CLOVER SHOPPING CENTER REDEVELOPMENT

PREPARED FOR
KRAUS
ANDERSON
BLOOMINGTON MINNESOTA

CLOVER SHOPPING CENTER EXHIBIT

CLOVER SHOPPING
 CENTER EXHIBIT - DRIVE
 EXTENSION

EX 1

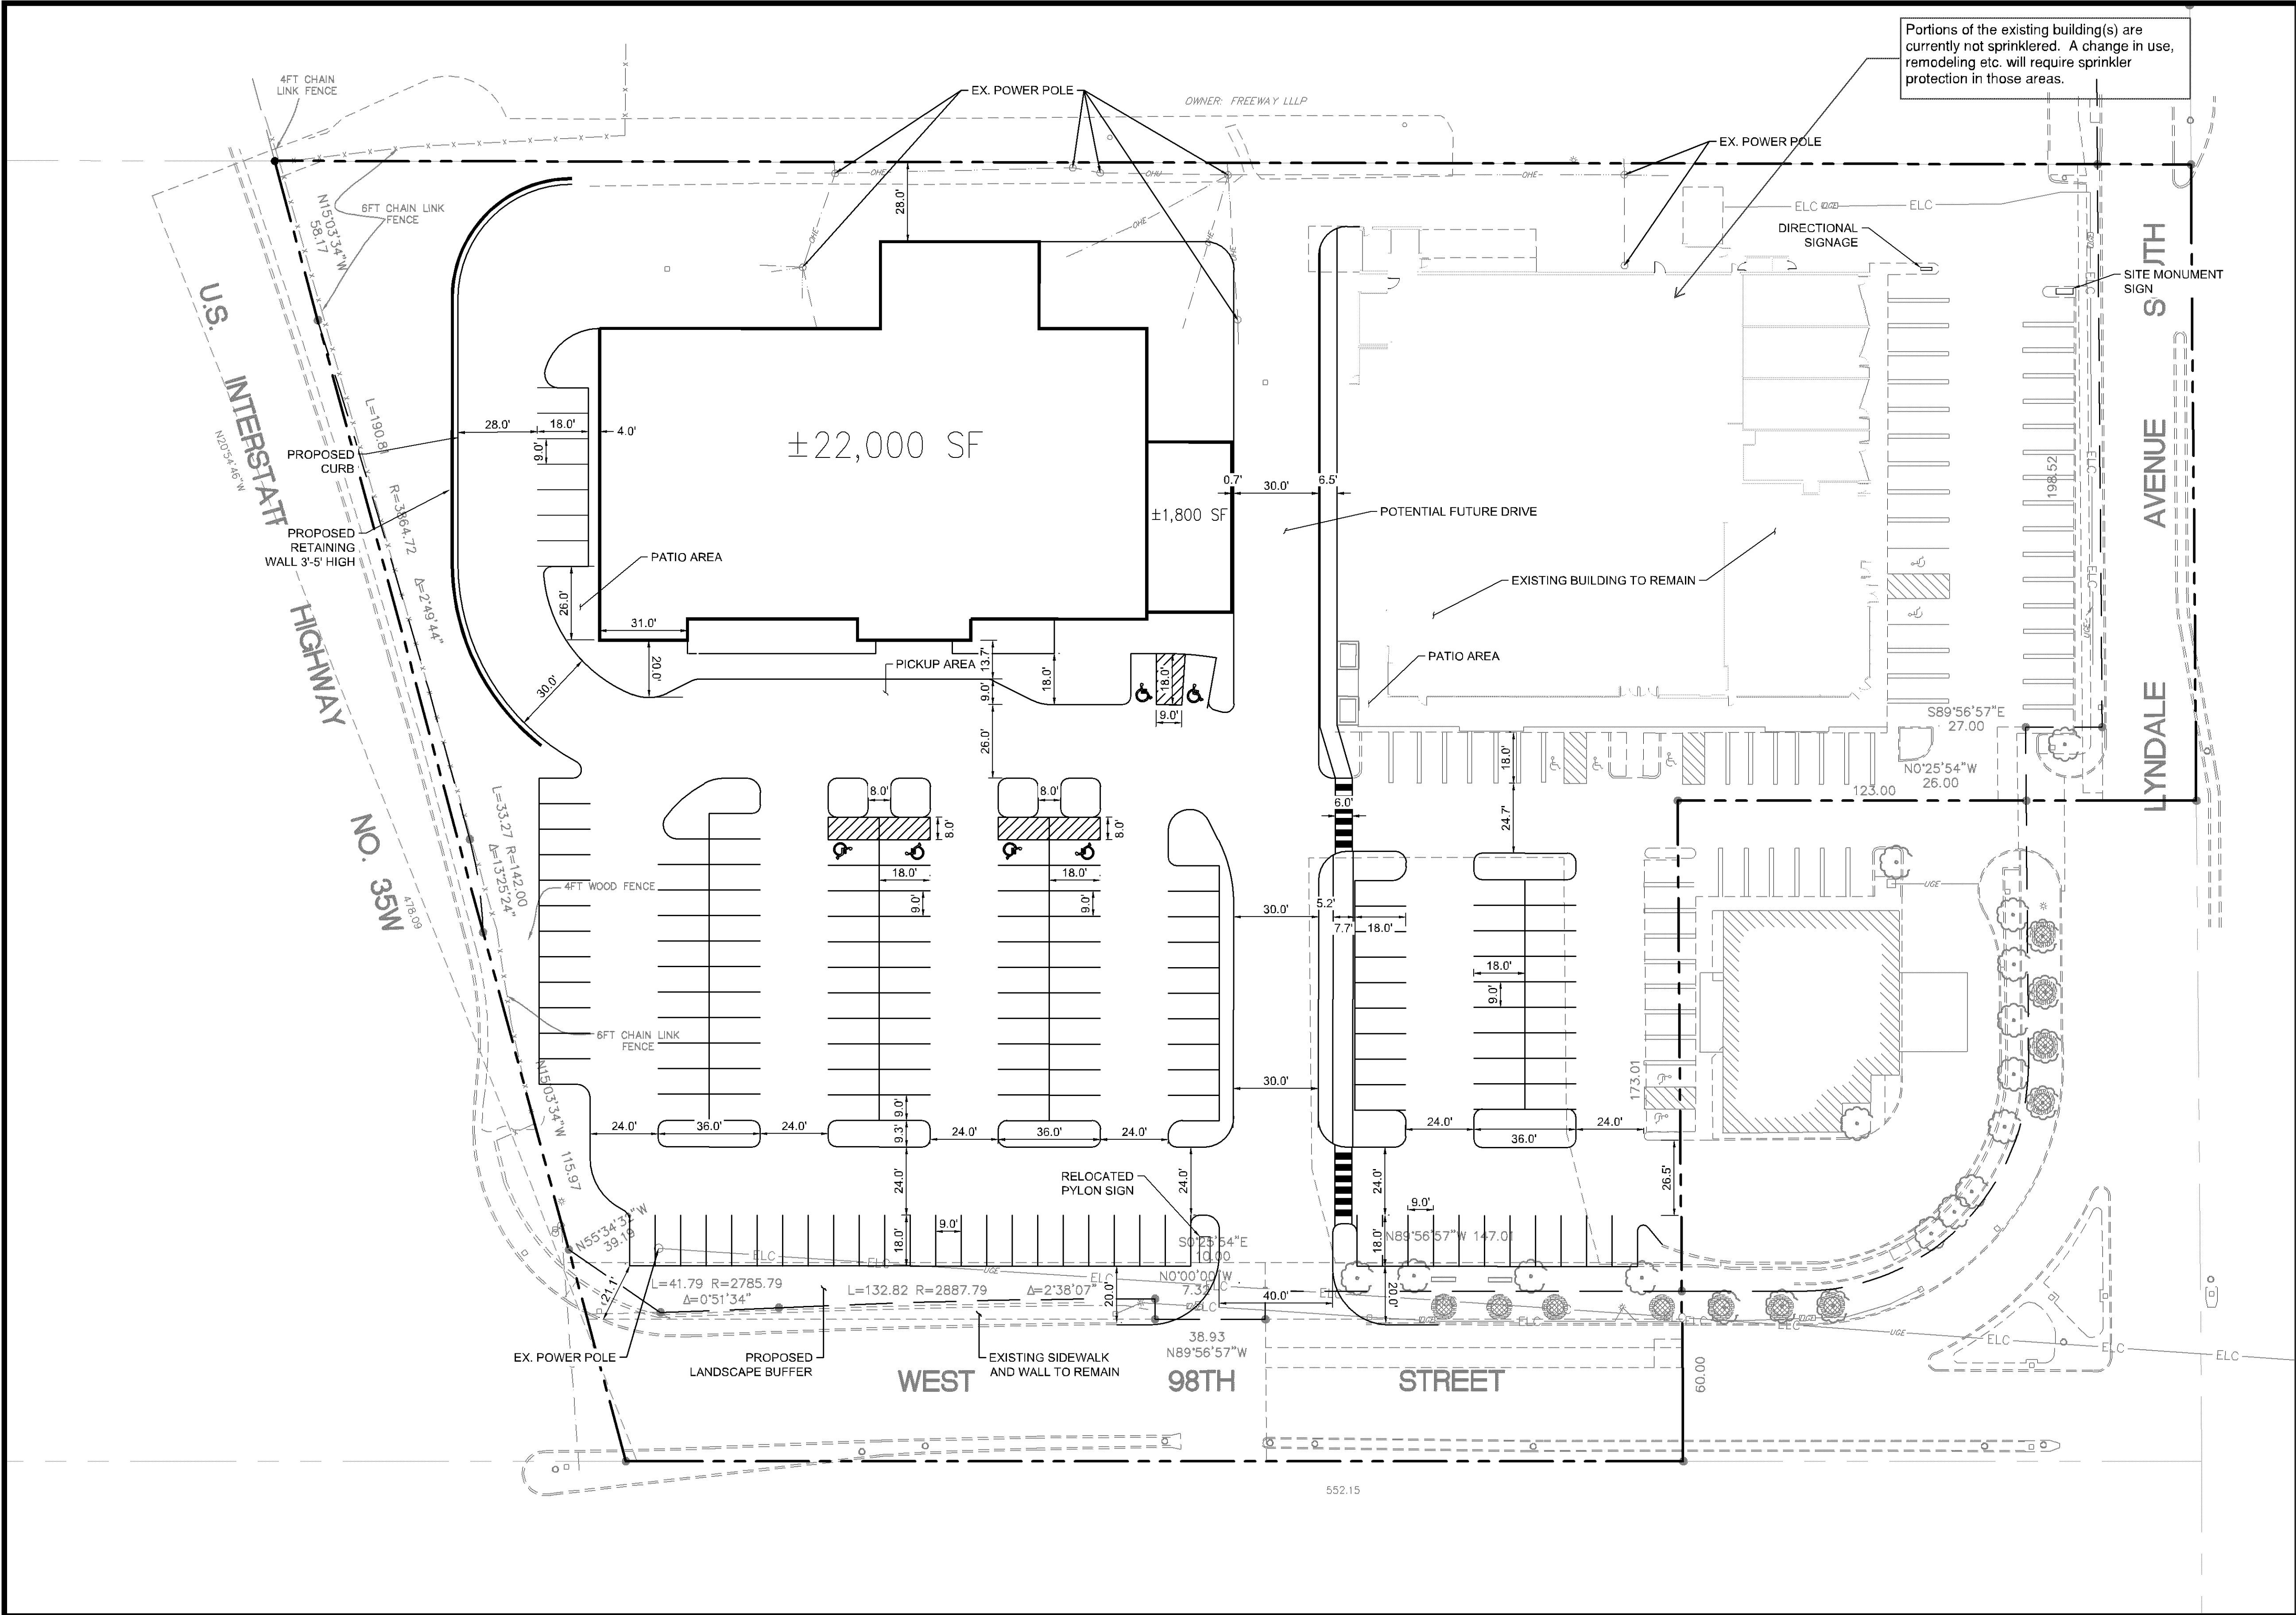
Must meet 2020 MN State Building Code

Must meet 2020 MN Accessibility Code.

Provide a detailed code analysis with the plans.

SAC review by MET council will be required.

Building plans must be signed by a MN licensed architect.

At least one deciduous tree is required for each parking island. A three-foot landscaping screen is required along the street. The plantings along Lyndale Avenue do not provide a screen and will need to be replaced with alternative plantings.

The parking along MnDOT right of way is less than the 20-foot minimum. Development flexibility is required.

Depict the sidewalk along W. 98th Street. City Code requires a minimum 8-foot concrete sidewalk.

Freestanding signs require a 20-foot setback from property lines along streets.

It makes sense to align parking on both sides of the access drive. However, because the setback is less than 20 feet, development flexibility is required.

Consider locating freestanding sign where directional sign is proposed on north side of the site.

Existing Clover Center Sign must be relocated/removed.

Freestanding signs require a 20-foot setback from property lines along streets.

The overall parking requirement with the proposed redevelopment would decrease. Please provide the uses for tenant spaces, including the number of seats for restaurants. Staff will prepare a parking analysis to determine the level of deviation from City Code. Depending on the level of deviation, a parking study may be necessary prior to the City accepting a development application

A traffic study will be necessary prior to the City accepting a development application

EX 2

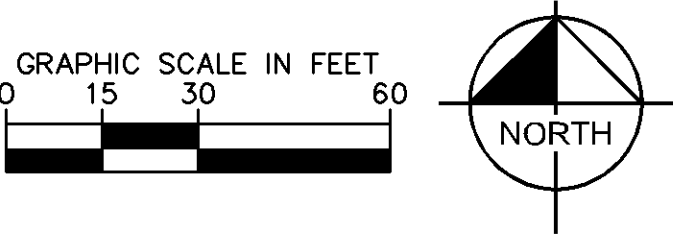
Provide adequate turning radius for BFD Ladder 3.

Additional hydrants will be required to provide coverage within 150' of all exterior walls.

"EX 2" could be identified as a Phase II for the Clover Center preliminary development plan. Also envision what a Phase III and any additional phases would entail.

The City has very specific standards pertaining to exterior building materials. Brick, glass, and stucco are permitted primary building materials. There are limitations on "secondary" materials such as EIFS and fiber cement panels. Metal panels may be permitted as "primary" material, subject to finish warranty and gauge requirements.
